PAINT BRUSH HILLS FILING 14
PRELIMINARY SITE MAP

PAINT BRUSH HILLS FILING 14
PRELIMINARY SITE MAP
Falcon, CO
El Paso County, CO

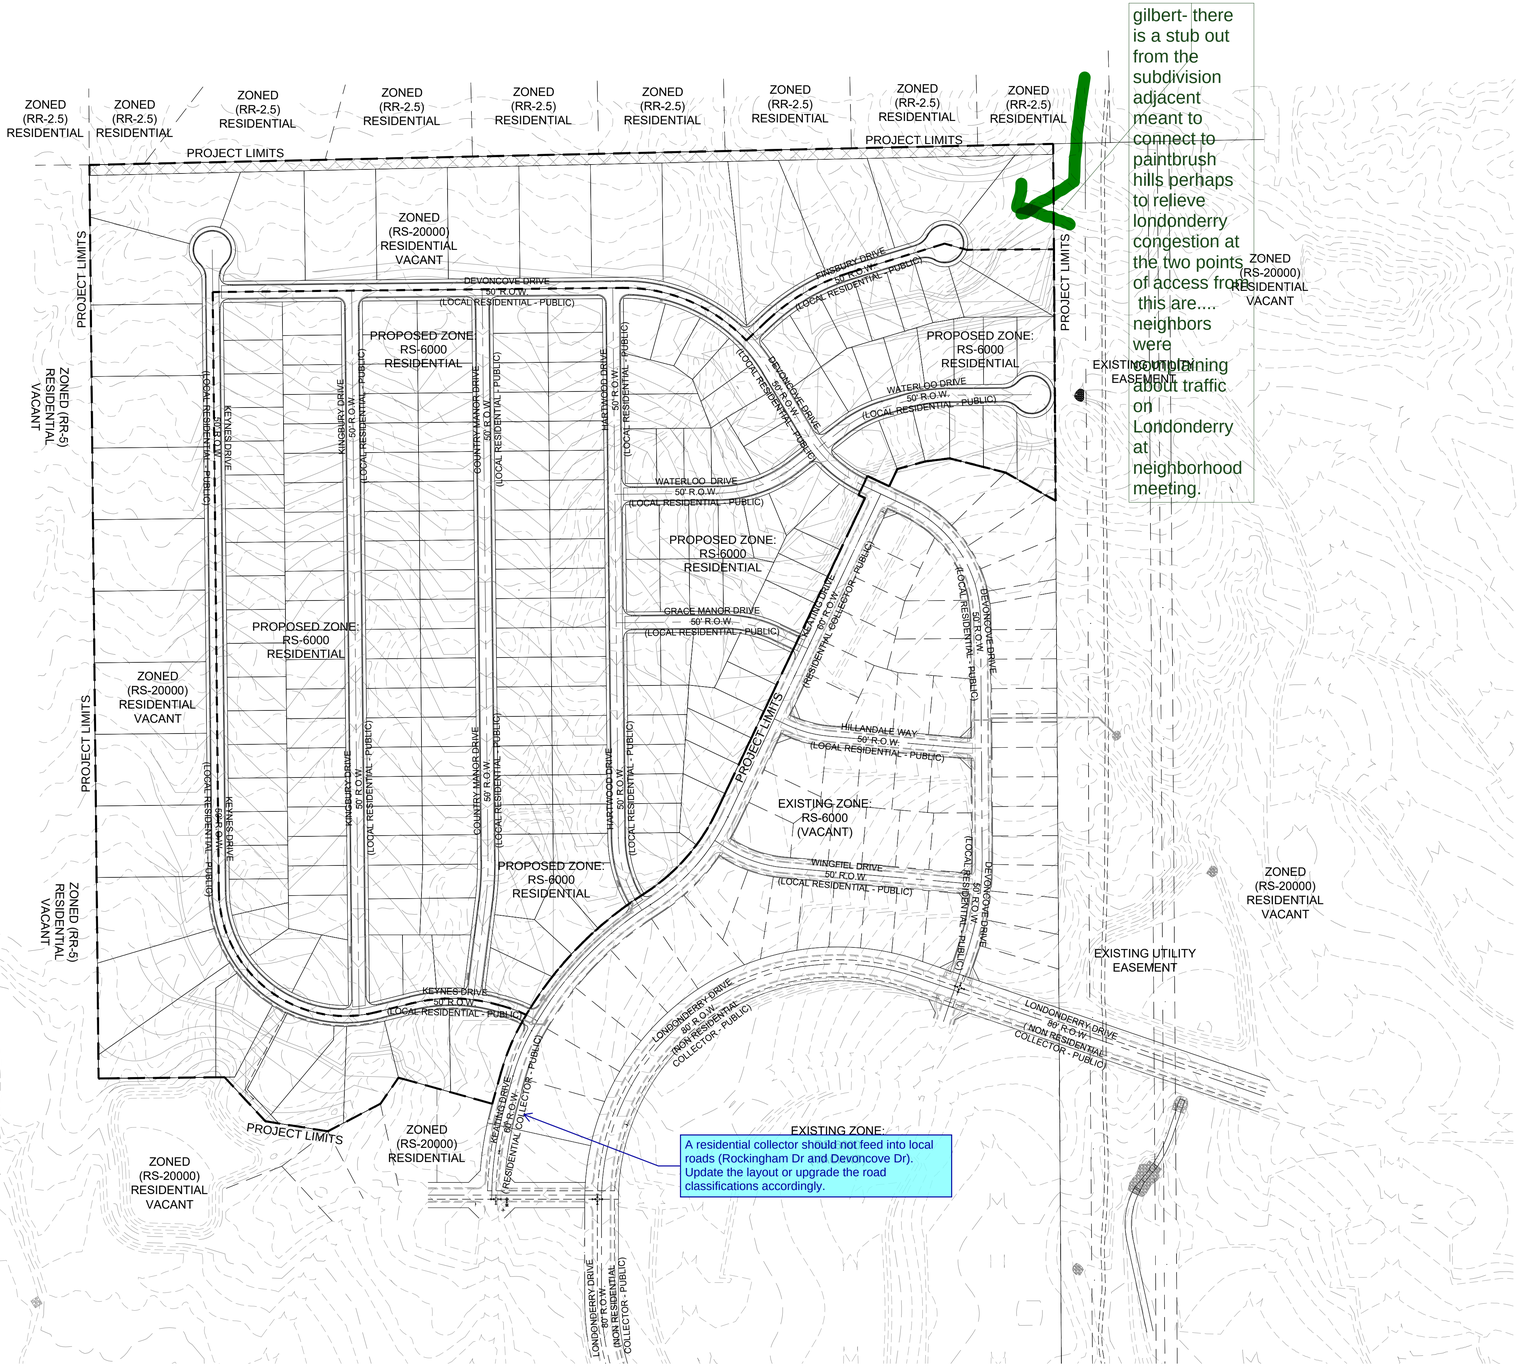
Concept

and 15?

gilbert- there is a stub out from the subdivision adjacent meant to connect to paintbrush hills perhaps to relieve londonderry congestion at the two points of access from this are.... neighbors were concerning about traffic on Londonderry at neighborhood meeting.

A residential collector should not feed into local roads (Rockingham Dr and Devoncove Dr). Update the layout or upgrade the road classifications accordingly.
